STAFF REPORT ADDENDUM

PCA B-715
Concurrent with RZ 2015-MV-015 and
SE 2015-MV-030

APPLICANT: L & F Bock Farm, LLC

PROPOSAL: To permit deletion of 4.38 acres from RZ B-715.

LANDSCAPE PLAN

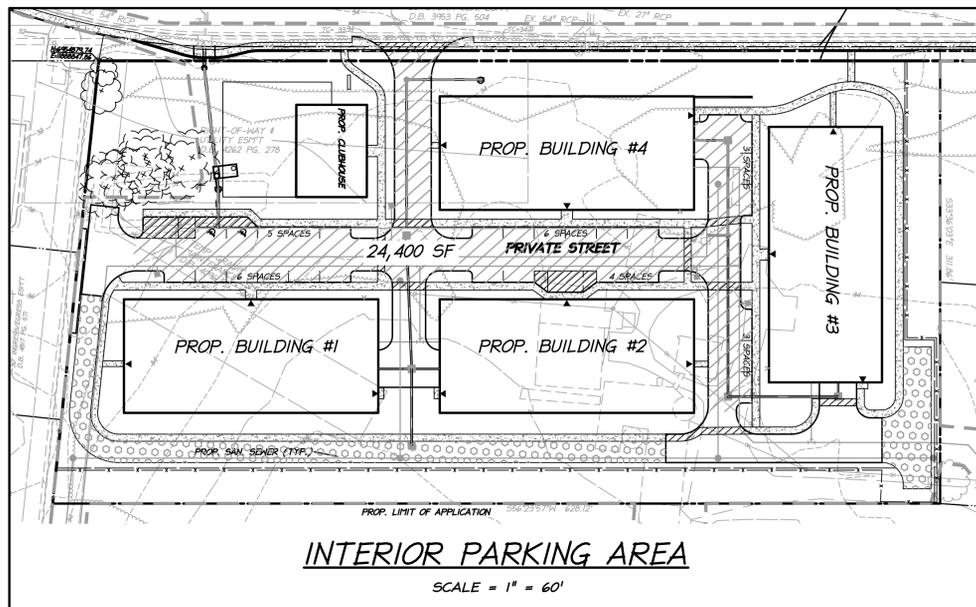
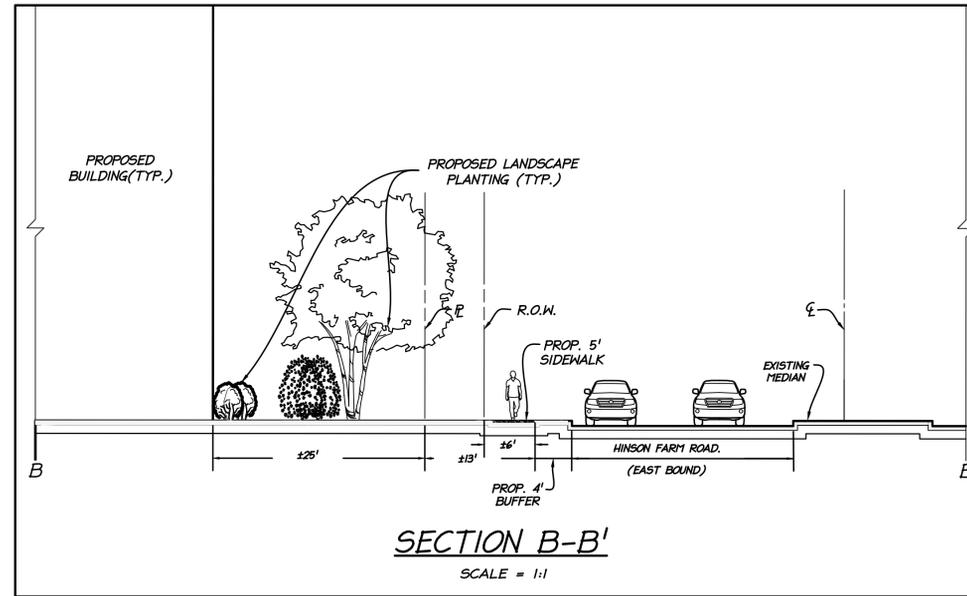
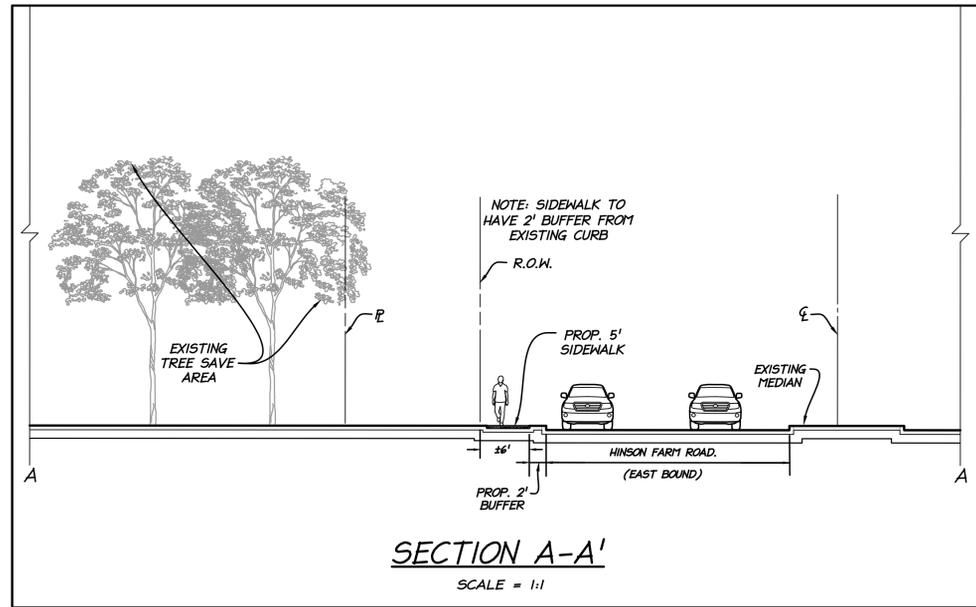
As noted, the applicant revised their development plan for the addition of a loading space by reducing two surface parking spaces. The reduction of two surface parking spaces in exchange for an additional loading space does not affect the parking spaces required by the Zoning Ordinance. The Zoning Ordinance requires 33 parking spaces and the applicant is providing 155 parking spaces (27 surface and 128 underground parking spaces). This modification addresses staff's outstanding concern related to loading.

The only update to the analysis of the modifications and waivers is for a modification on the number of loading spaces required by Sect. 11-203 of the Zoning Ordinance. The required number of loading spaces is four. The applicant is now proposing two loading spaces. Staff believes that while a modification is still needed, that the two loading spaces provide adequate access to the buildings on site and staff now supports the modification.

The applicants revised their GDP/SE Plat to reflect concerns from staff and the Planning Commission by the addition of one loading space. The applicant increased their contributions to the Park Authority and the traffic signal preemption devices. While the applicant has updated the contribution amount to the Park Authority, the amount is still below what staff recommended.
